DESCRIPTION OF WORK: 1. REMODEL FORMER MEN'S LOCKER, SHOWER, SUNA, AND RESTROOM FACILITIES FOR USE BY WOMEN TO GAIN A DIGNITY BETWEEN MEN'S & WOMEN'S FACILITIES. 2. INSTALL A NEW ARTICLE IS ELEVATOR TO PROVIDE A PATH OF TRAVEL TO THE REMODEL AREA. 3. ALTER & / OR REMODEL OTHER FEATURES, TO PROVIDE ACCESS, INCLUDING MEN'S RESTROOM, STAIRWAYS, DOORS, AND SIGNAGE.

DOLPHIN CLUB
S WIMMING & BOATING
SAN FRANCISCO
ORGANIZED 1977
LOCKER ROOM & SHOWER EXPANSION

SITE/ROOF
PLAN; GENERAL
INFORMATION

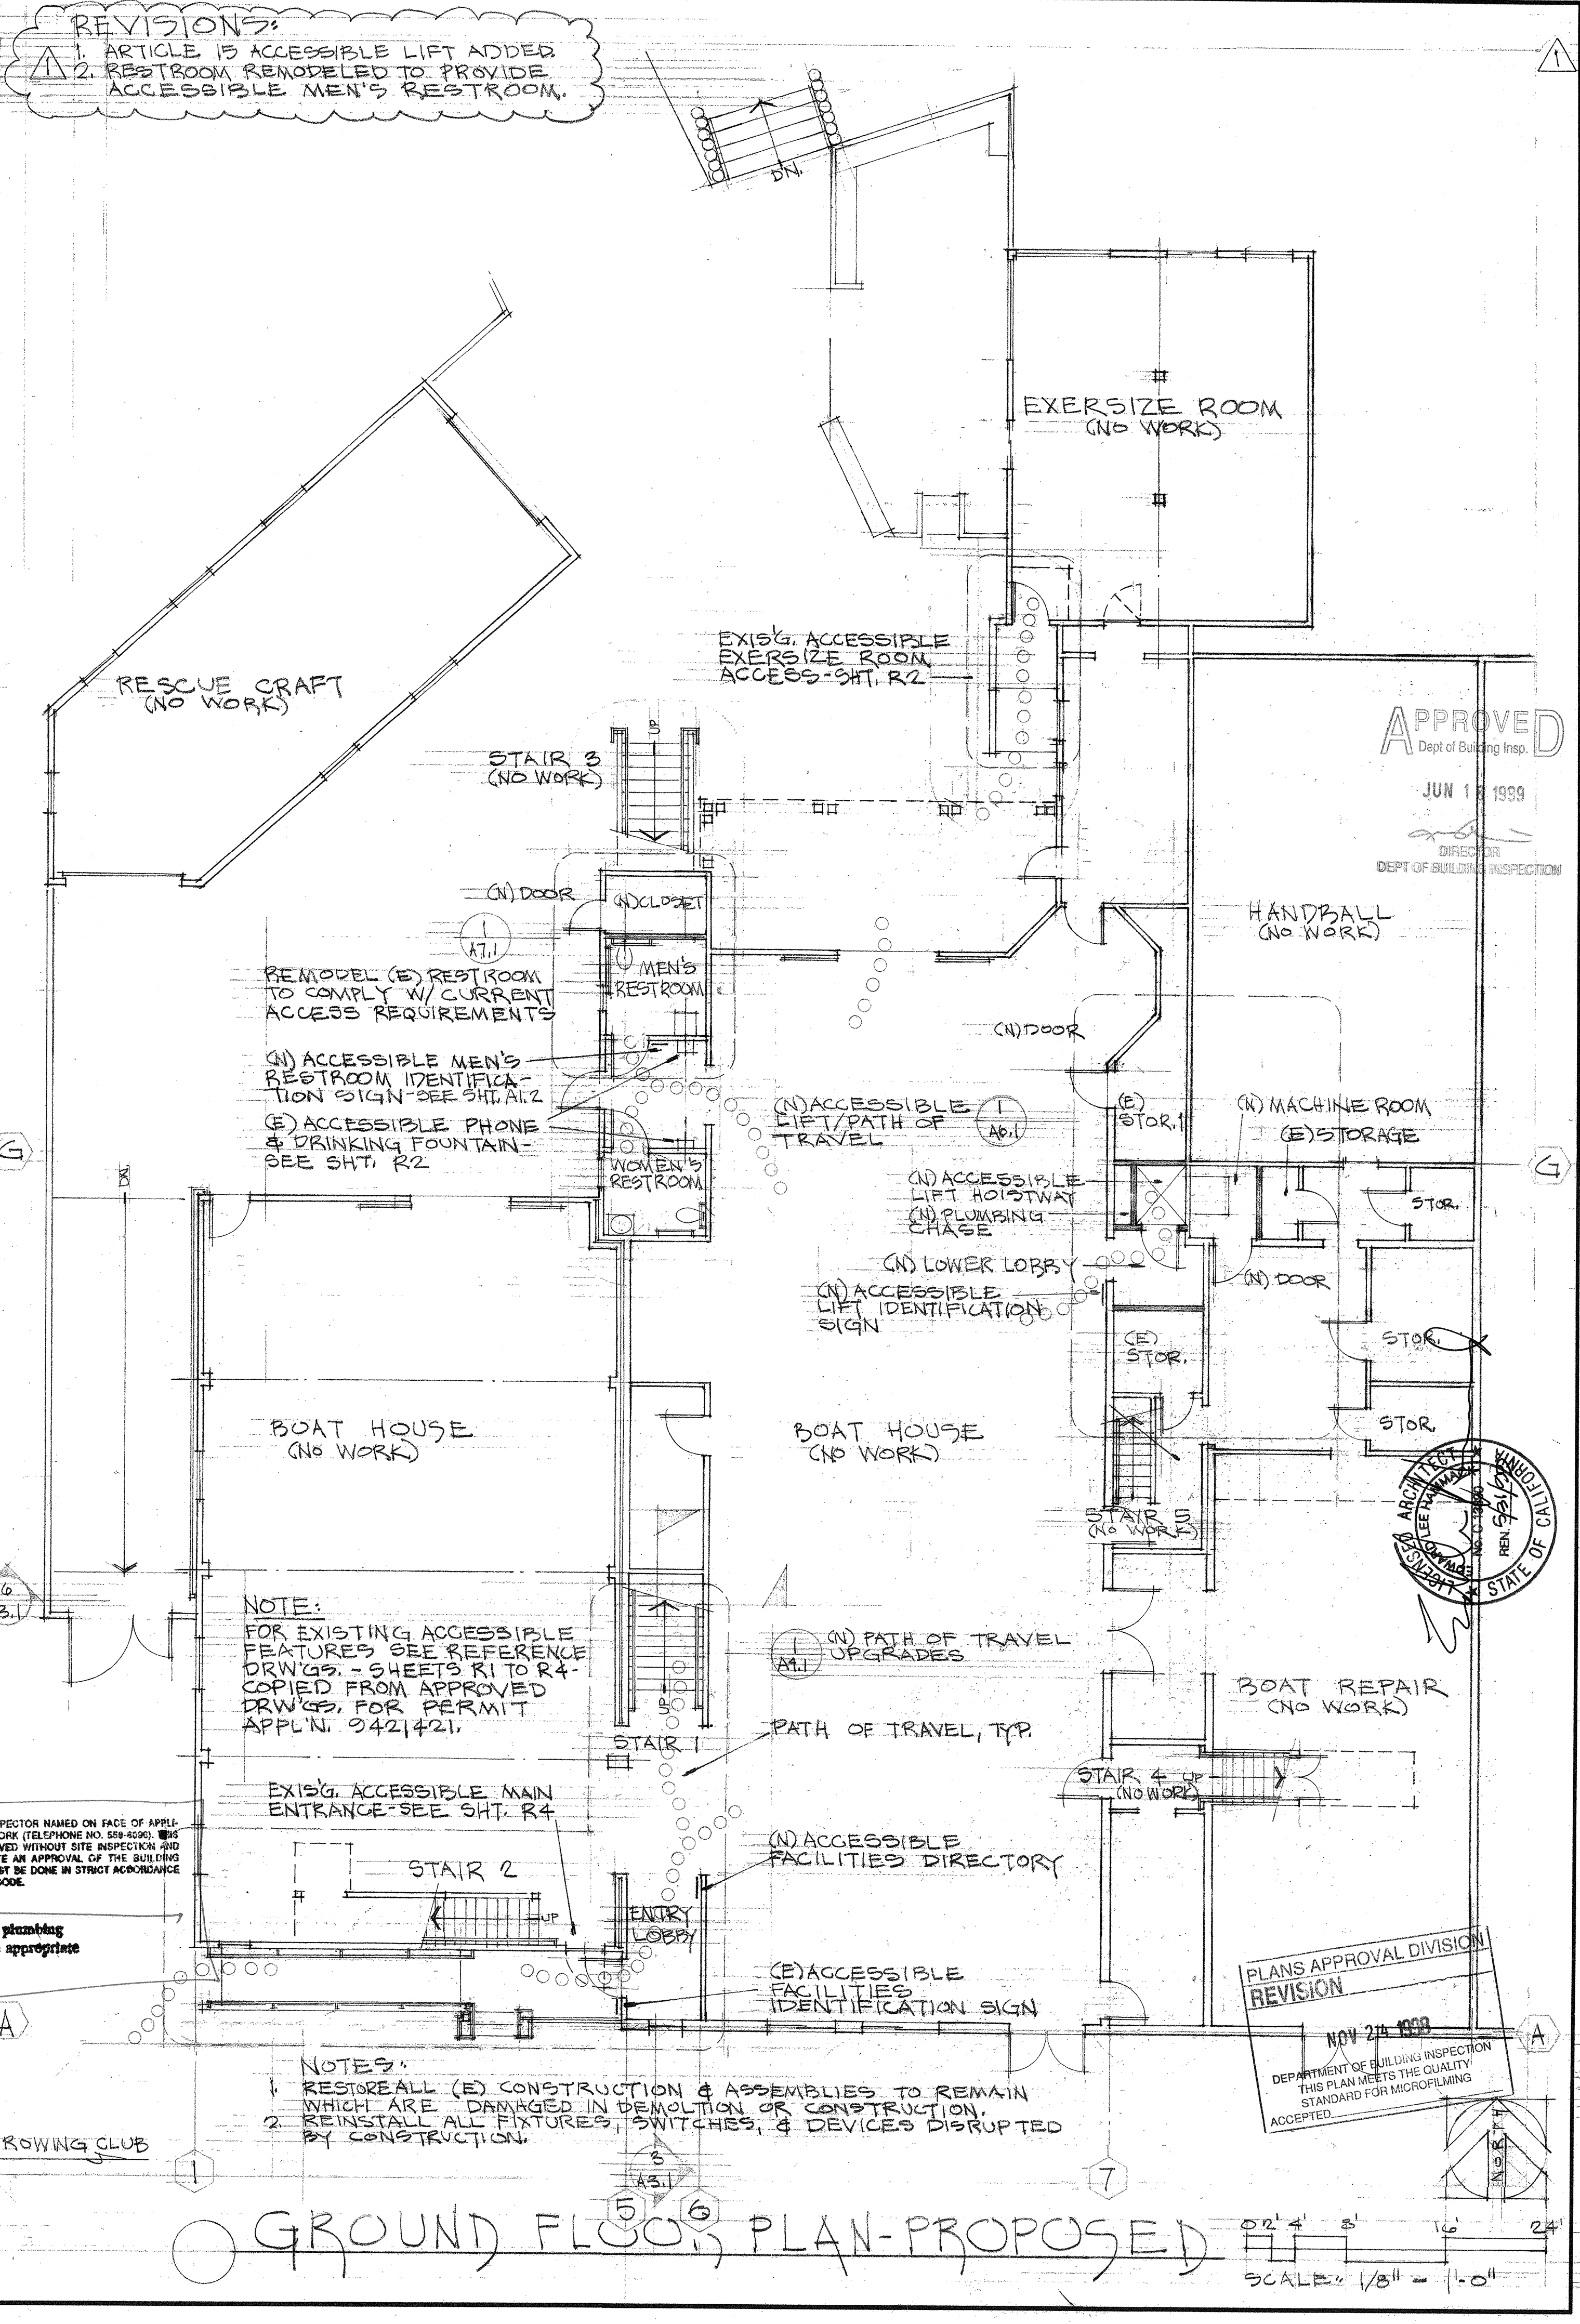
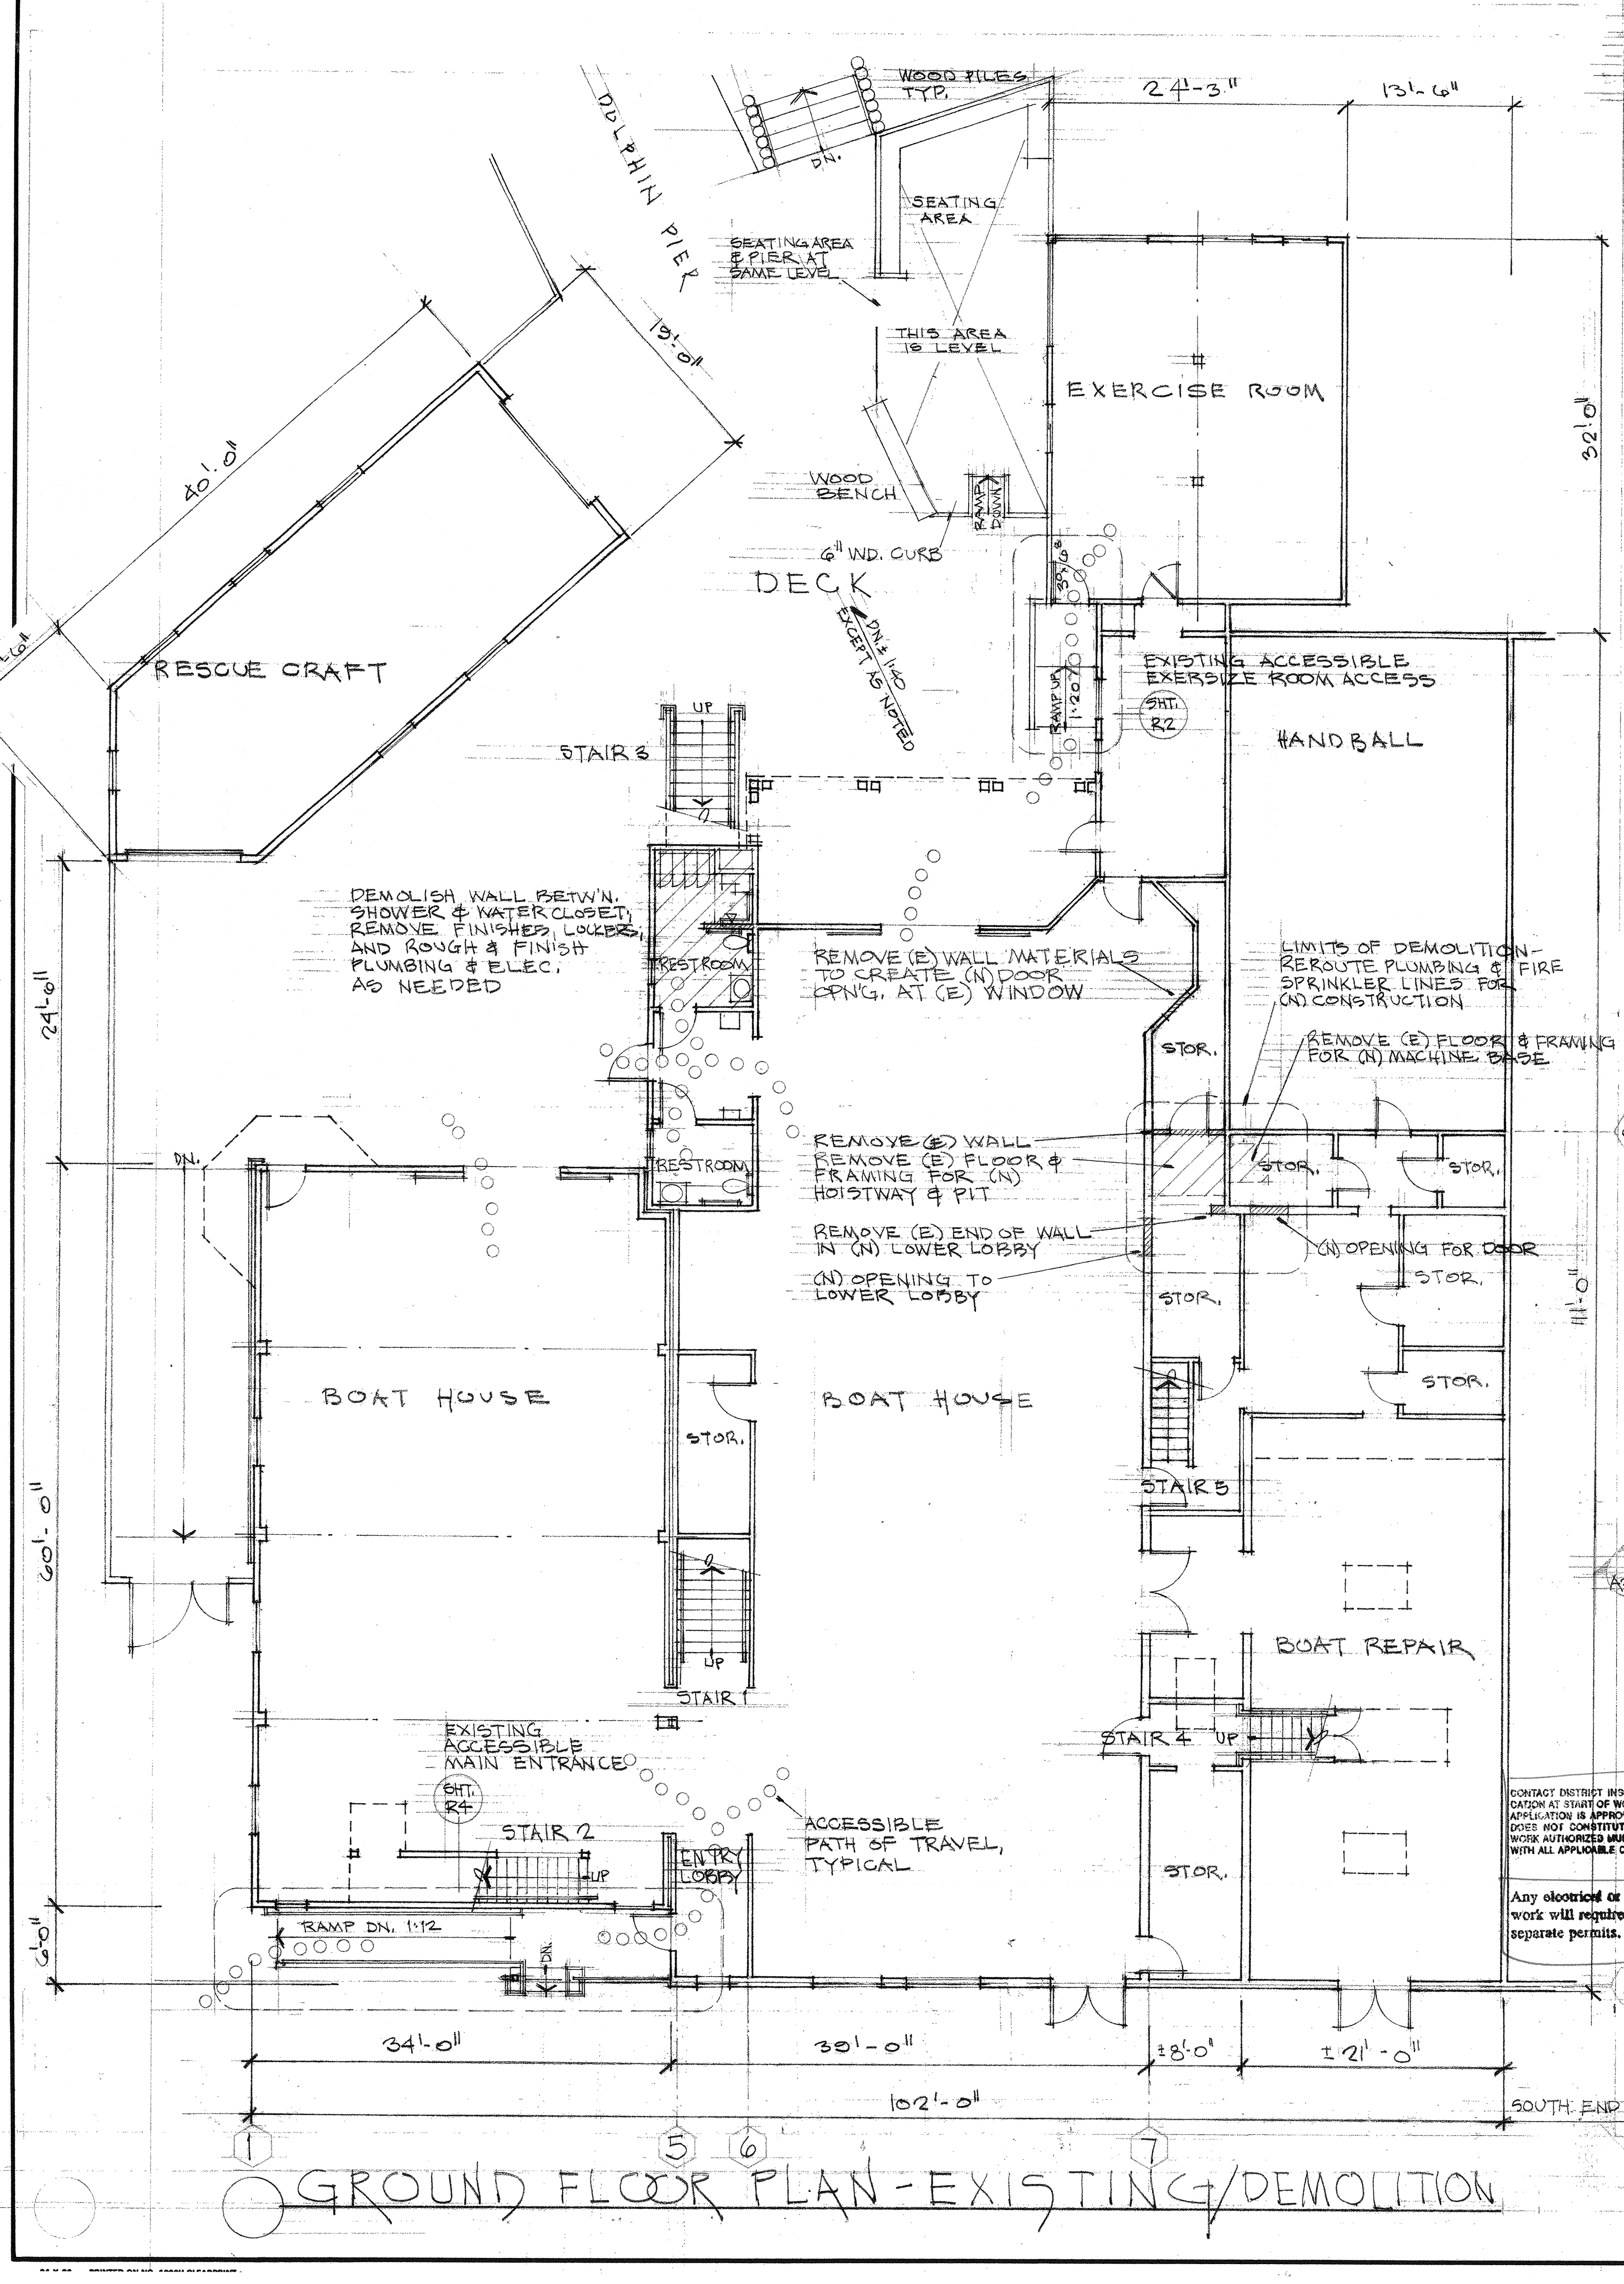
REVISIONS:
1. ARTICLE 15 ACCESSIBLE LIFT ADDED
2. RESTROOM REMODELED TO PROVIDE ACCESSIBLE MEN'S RESTROOM.

STOR. MEZZANINE LEVEL -
EXIST'G./DEMOL'N. &
PROPOSED

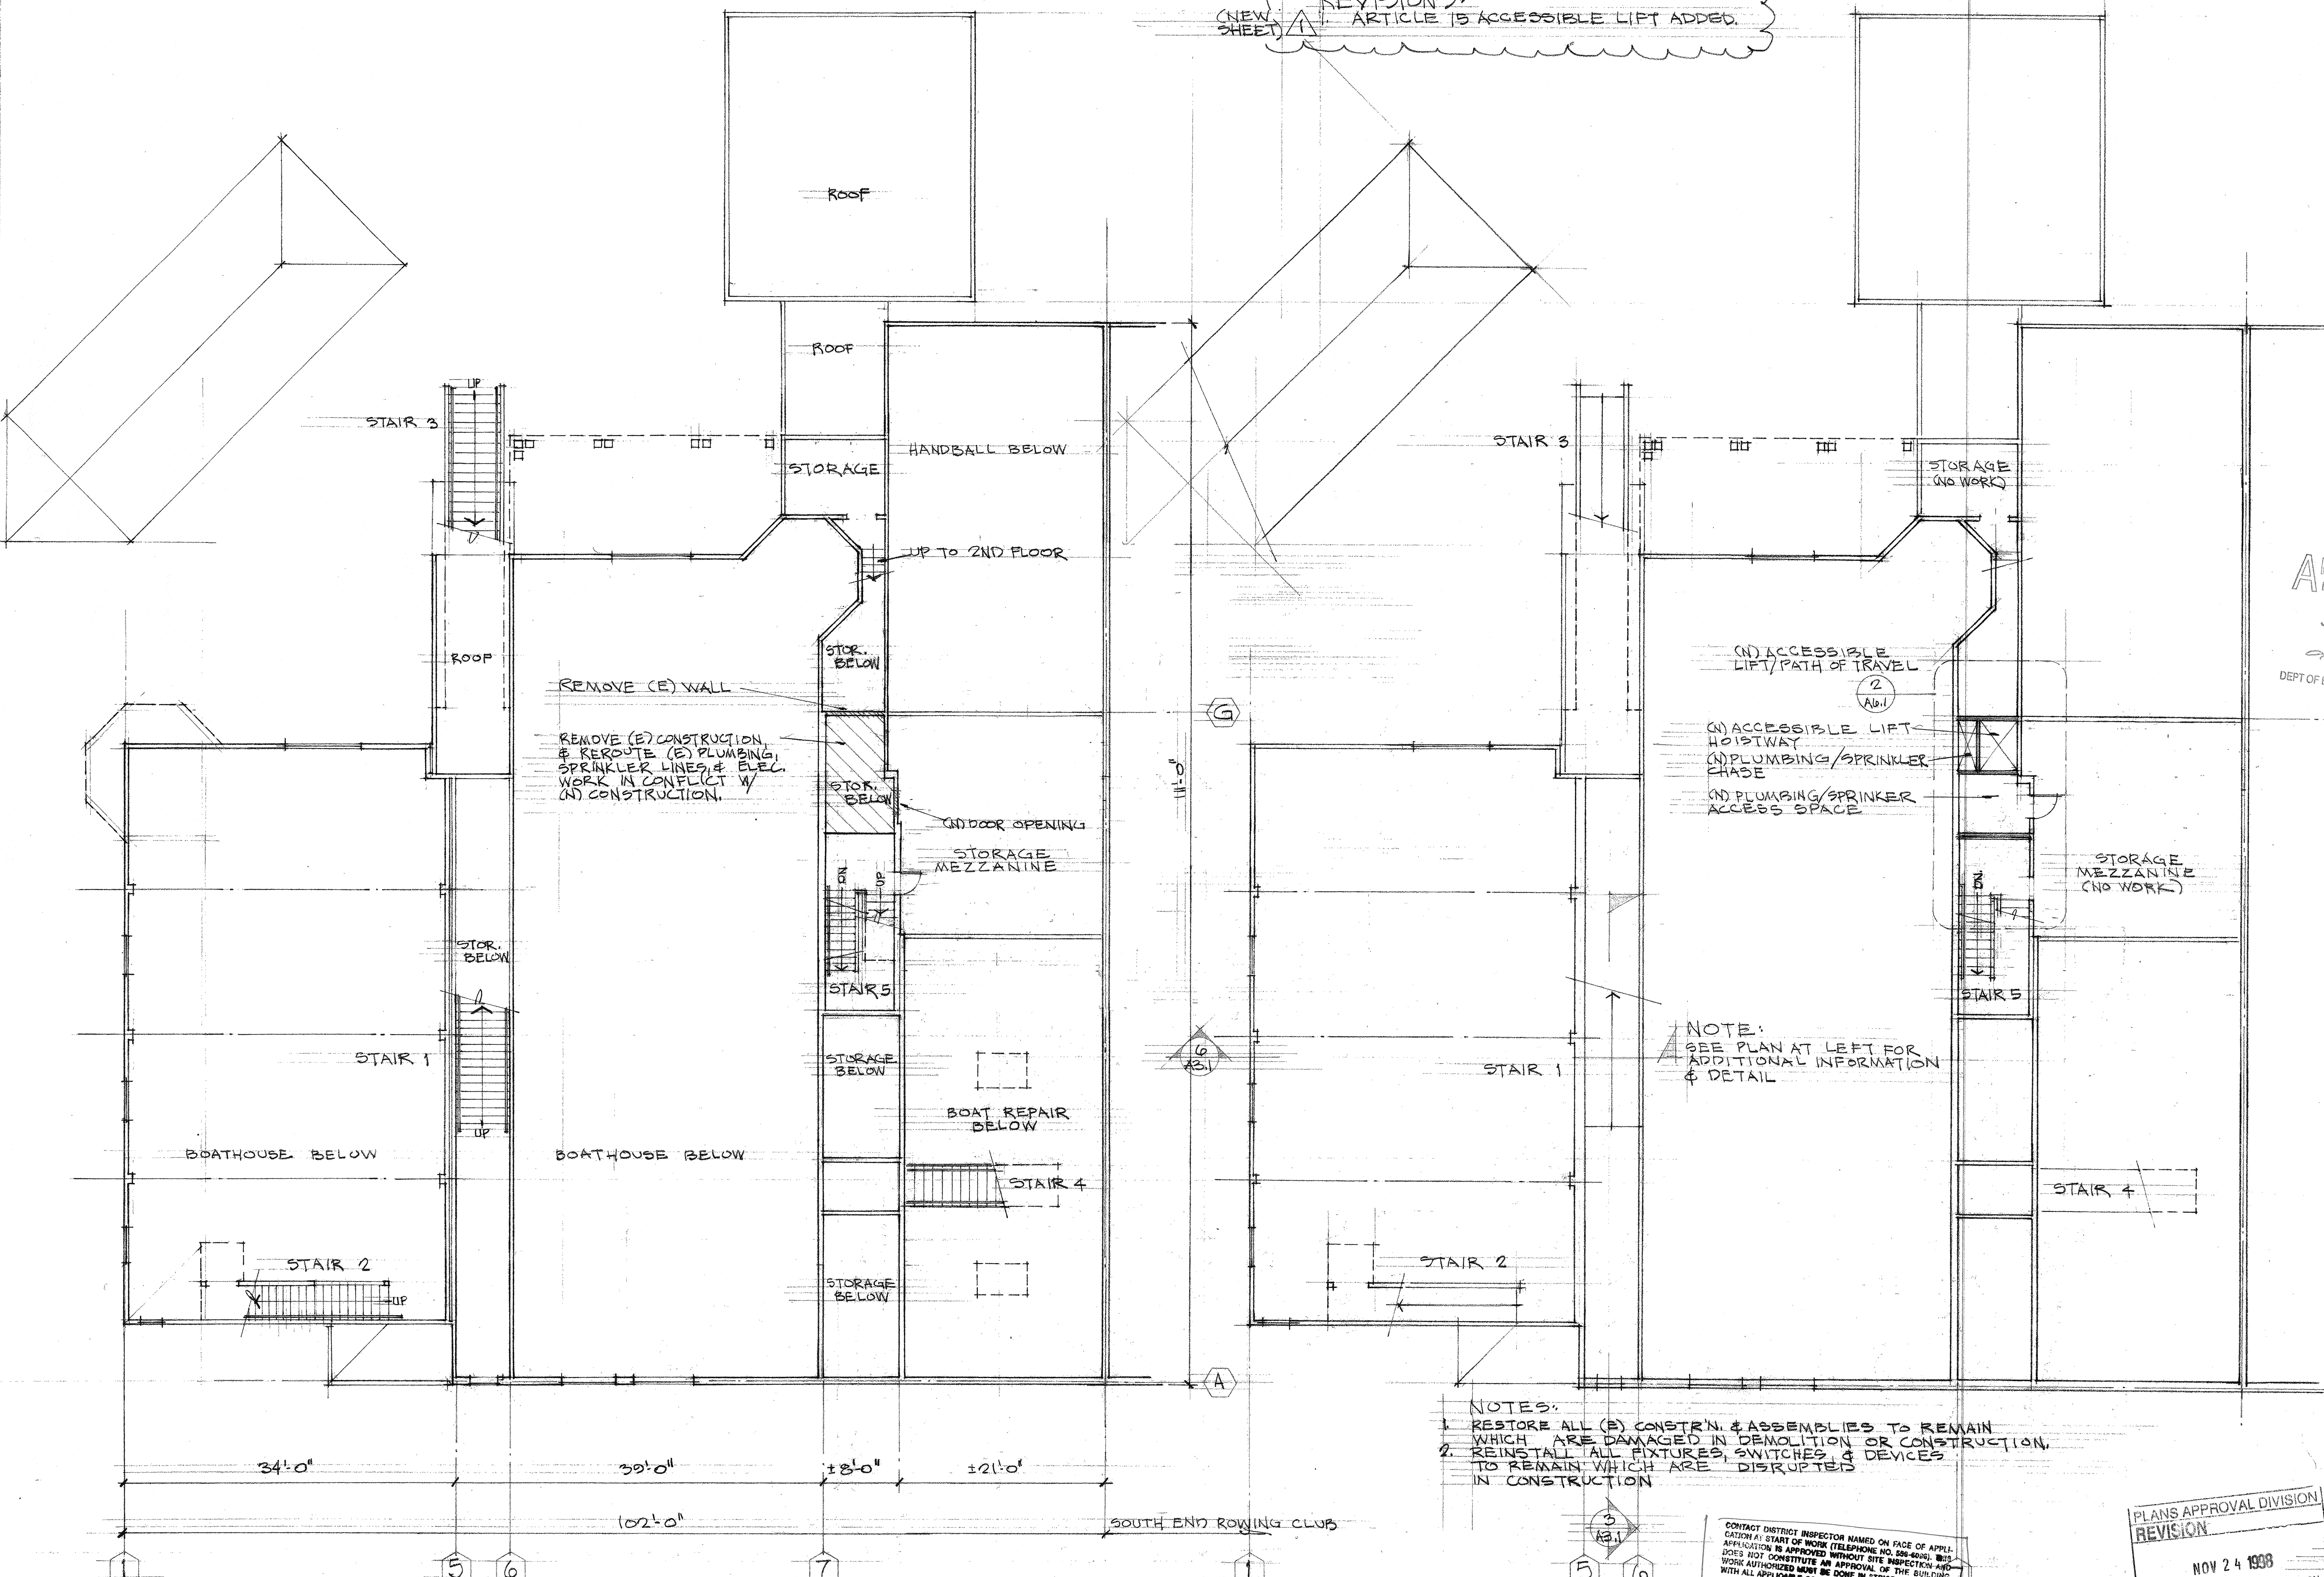
REVISIONS:
(NEW SHEET) ARTICLE 15 ACCESSIBLE LIFT ADDED.
